PRODUCT / PROCESS CHANGE INFORMATION

| 1.2 PCI No. | MICROCONTROLLERS/24/14814 |
| 1.3 Title of PCI | Microcontrollers (FC70, FC80): Activation "HDS" as Second Lead Frame Supplier (QFP100 14x14 Malta) |

Qualification Report Leadframe 5FT30182

Finished Device X-Ray Visual Analysis

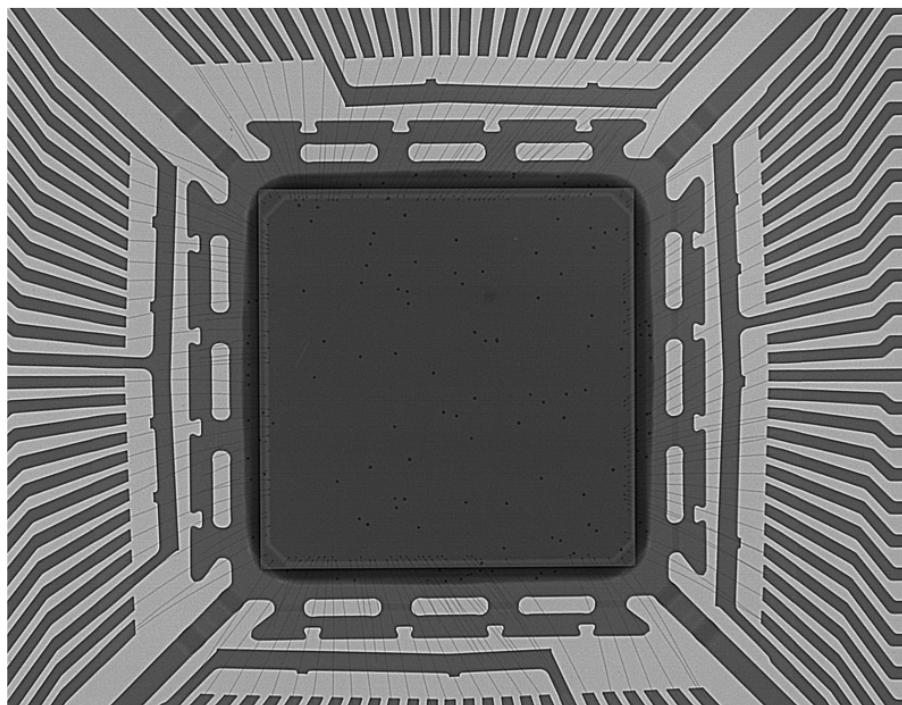
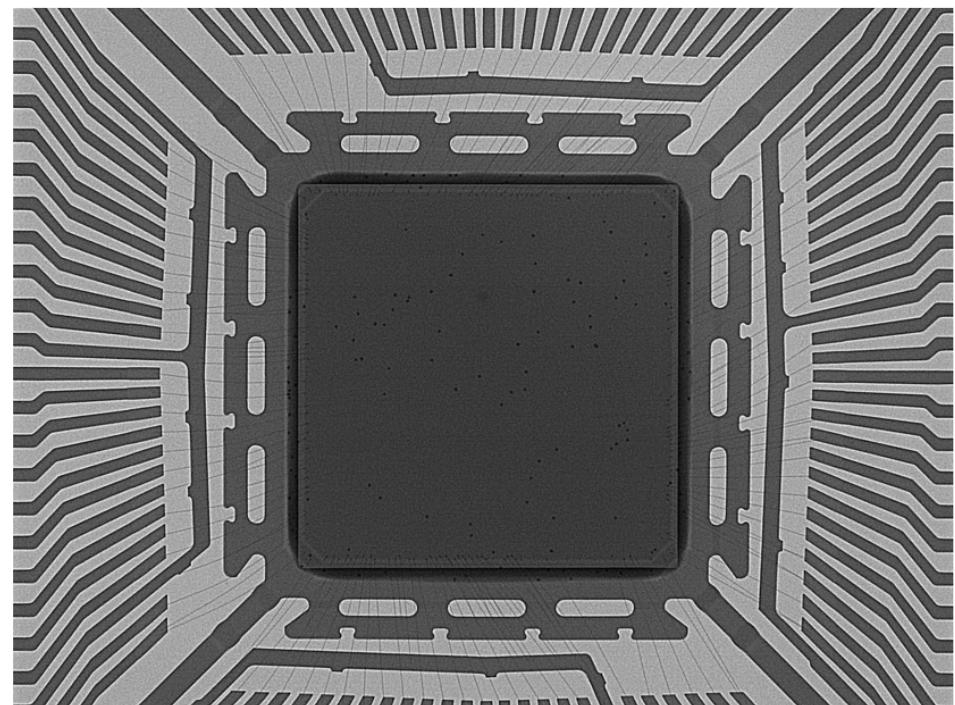
- Leadframe finishing (pre-plated from “Ni Pd Au” to “Ni Pd AuAg”)
- Leadframe unit design (minor differences).

Comparison between current and new Leadframe is reported in slides 5-6.
